**TOWN OF MOUNTAIN VILLAGE
REGULAR DESIGN REVIEW BOARD MEETING
AGENDA
THURSDAY MARCH 3, 2022 10:00 AM
MOUNTAIN VILLAGE TOWN HALL
455 MOUNTAIN VILLAGE BLVD, MOUNTAIN VILLAGE, COLORADO**

4.	10:35	45	Ward/Applicant	Quasi-Judicial	Consideration of a Design Review: Initial Architecture and Site Review for a new Single Family home on Lot 344R, 111 Rocky Rd., pursuant to CDC Section 17.4.11.

TO: Mountain Village Town Council
FROM: Amy Ward, Senior Planner
FOR: Design Review Board Public Hearing; March 3, 2022
DATE: February 23, 2022
RE: Staff Memo – Initial Architecture Review (IASR) Lot 344R, 111 Rocky Road

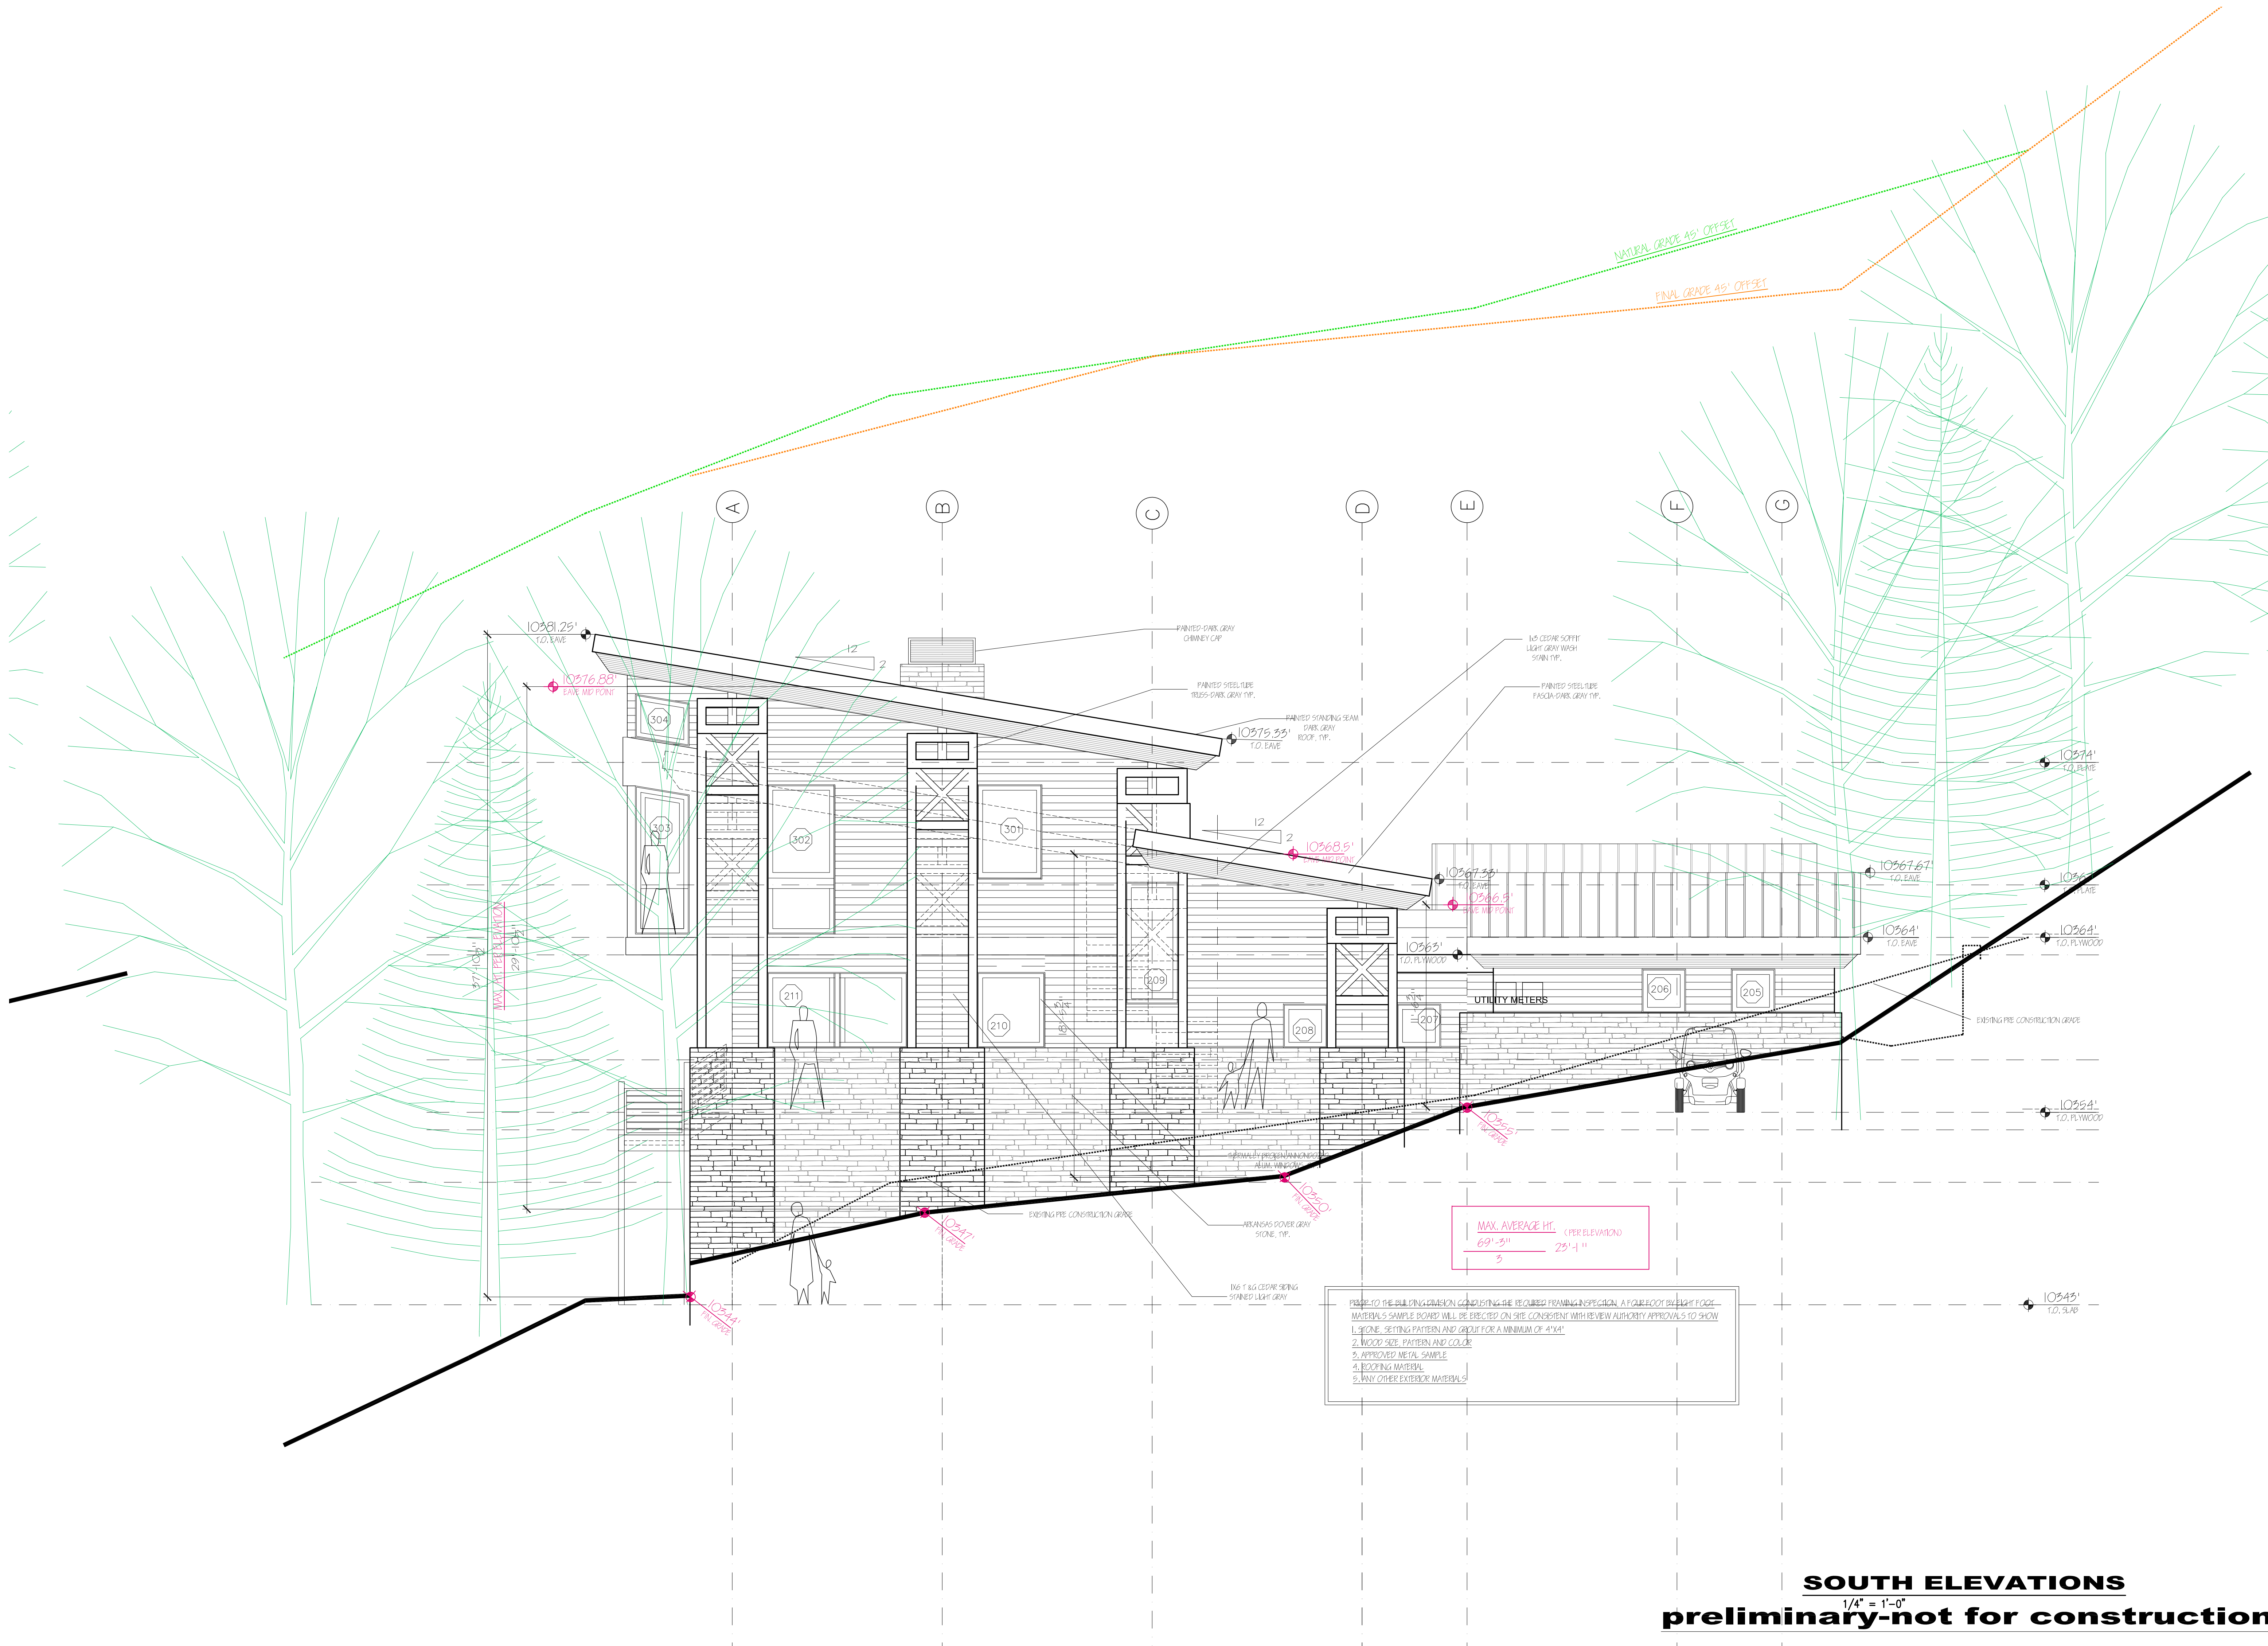
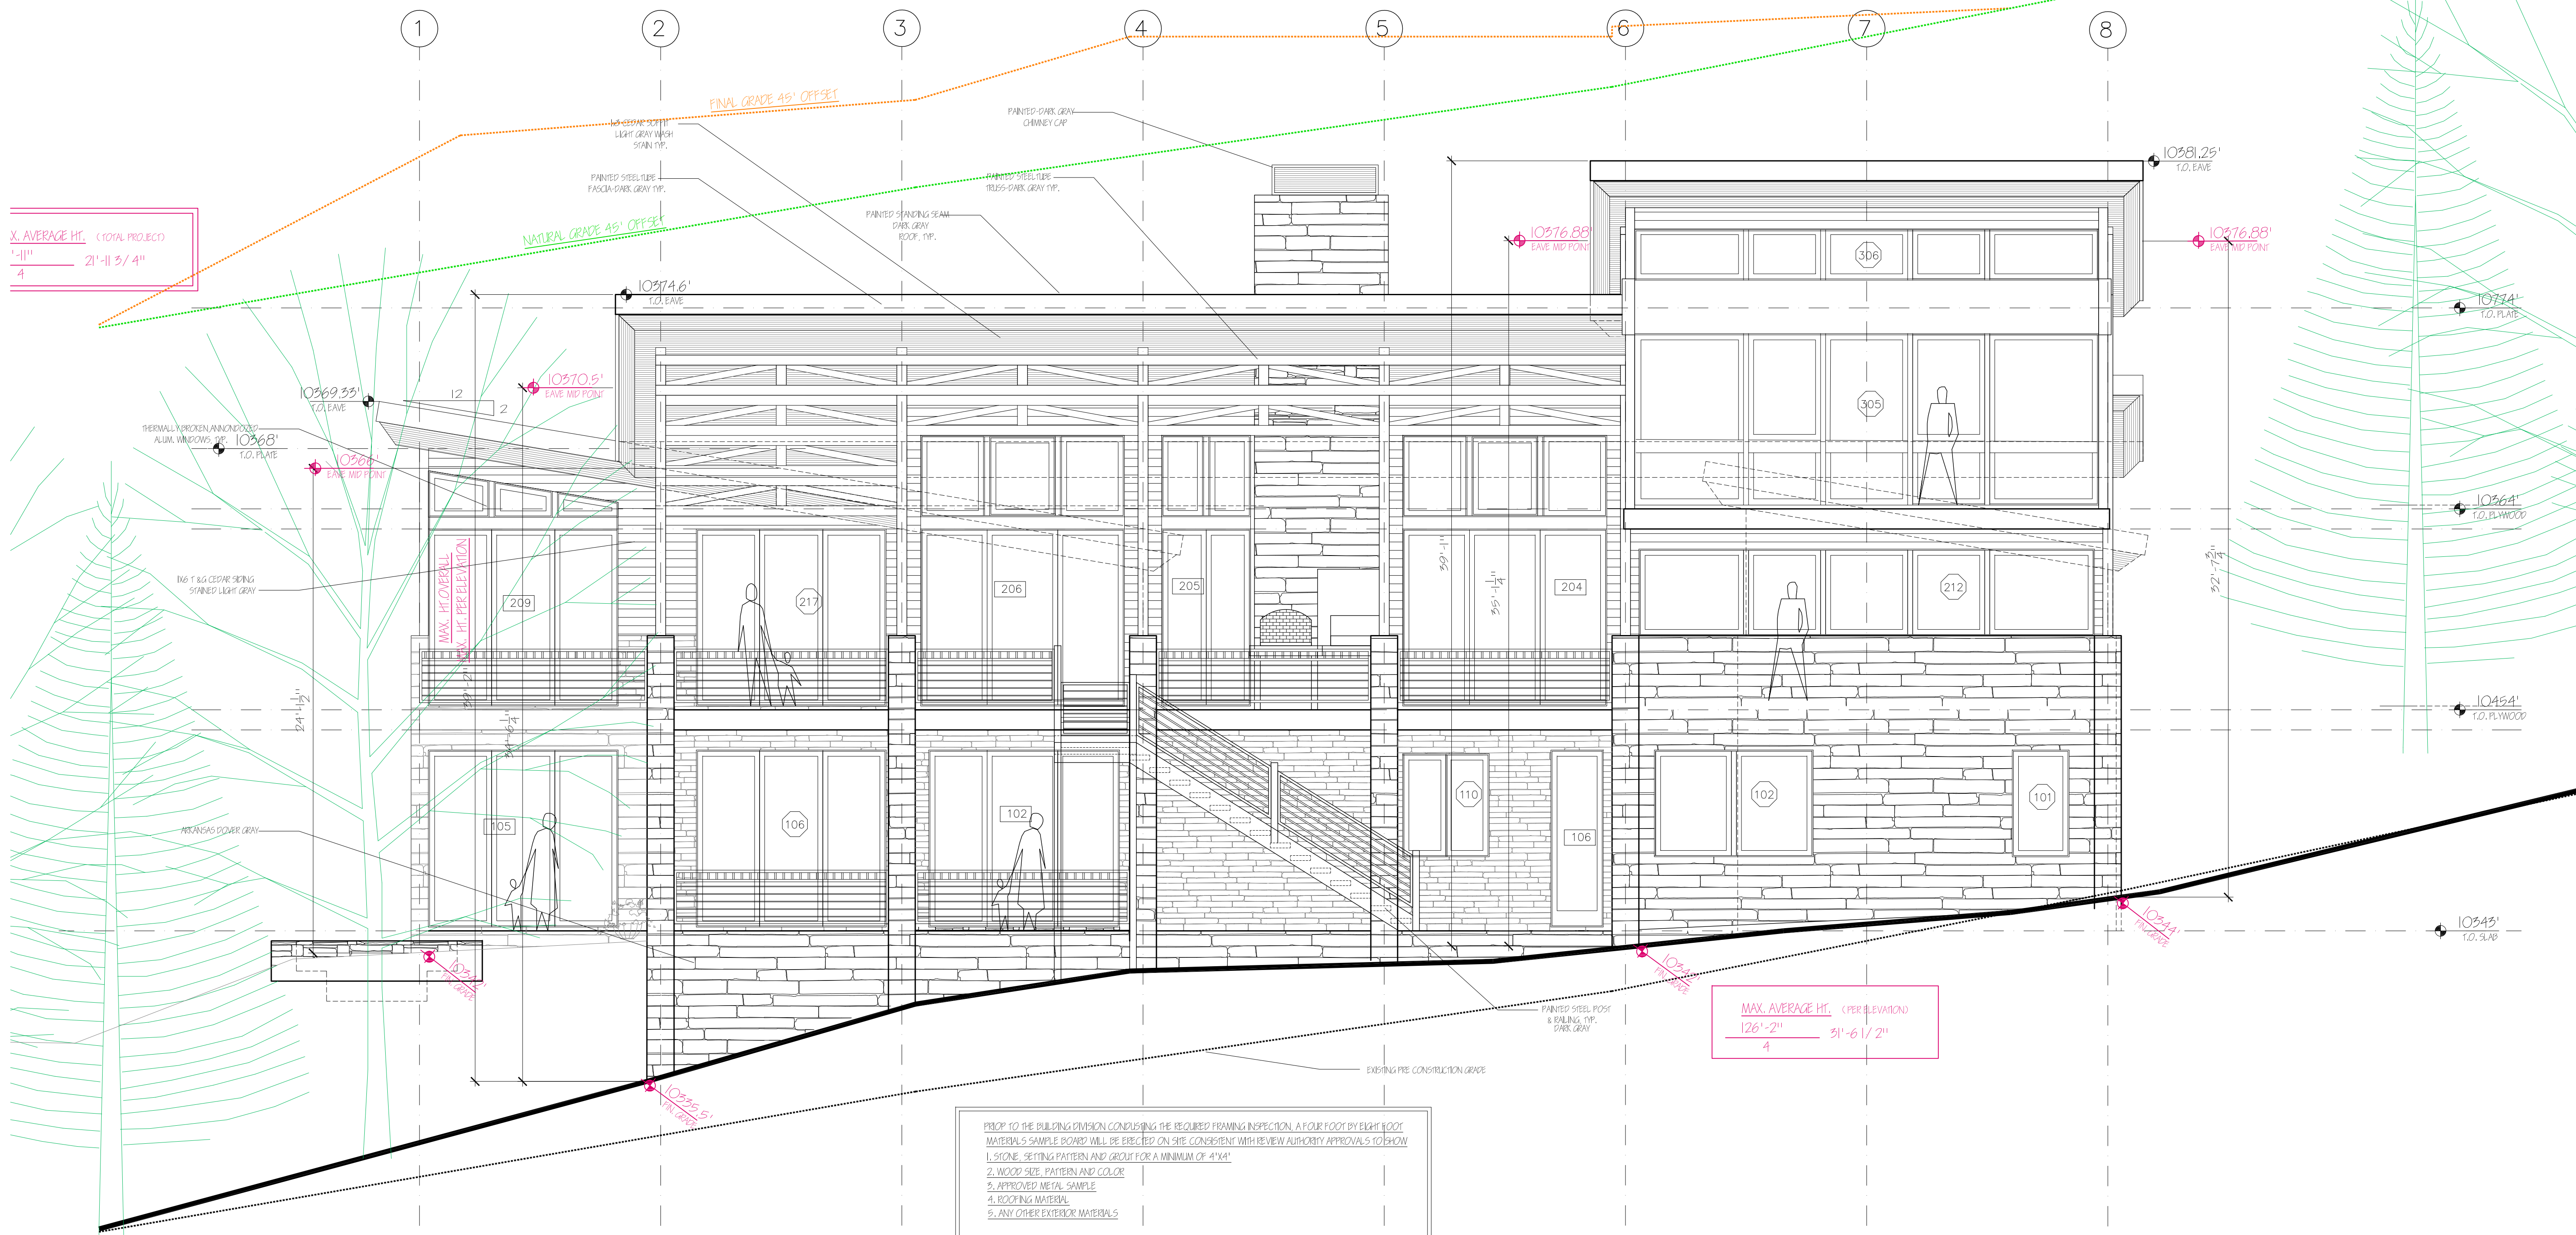
1. Construction fencing has been labeled on sheet A-1.1 Construction Staging Plan.
2. See Address monument location shown on sheet A-1.0 Site Plan at driveway and detail at sheet D-3.
3. See attached parking reservation agreements.
4. See attached parking reservation agreements
5. Deleted
6. See utility notes on sheet A-1.1 Construction Staging and civil utility plan.
7. Revised condo map will be filled after Final review.
8. See non combustible note on sheet A-4.0 building section.
9. See Improvement survey plat.
10. Ok.
11. See notes on exterior elevations A-3.2.
12. Ok.
13. Lighting has been reduced main deck level. We have eliminated (5) L1 fixtures.
